Project: Iqaluit –Road and Drainage Improvements	Addendum No.: 1
RFP No.: 2021-RFP-018	No. of Pages: 12
	Date: June 4, 2021
	Doc. No. P7201-1928275642-19

The following change(s) in the Request for Proposal Documents No. 2021-RFP-018 are effective immediately.

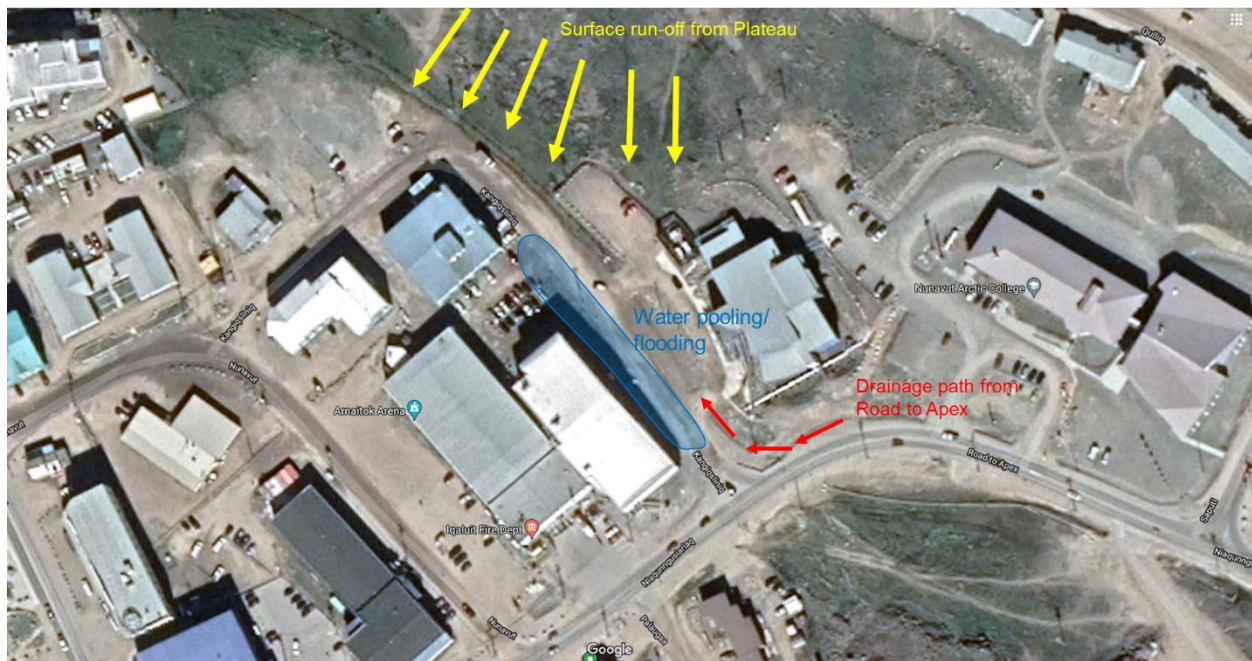
For item 6.3 of the RFP pertaining to the Drainage Improvements, additional details to the nature of the issue requiring drainage improvements are provided below:

There is currently a lack of ditch definition to channel water along Kangiqslineq Road. The road is low in this area with very limited crowning in order to divert the water to the ditch. The marked up photo below outlines the observations of the issue.

The anticipated drainage improvements will likely include the regrading of existing roadside ditches or the implementation of new roadside ditches. There may also be a requirement to install a road crossing culvert if deemed necessary.
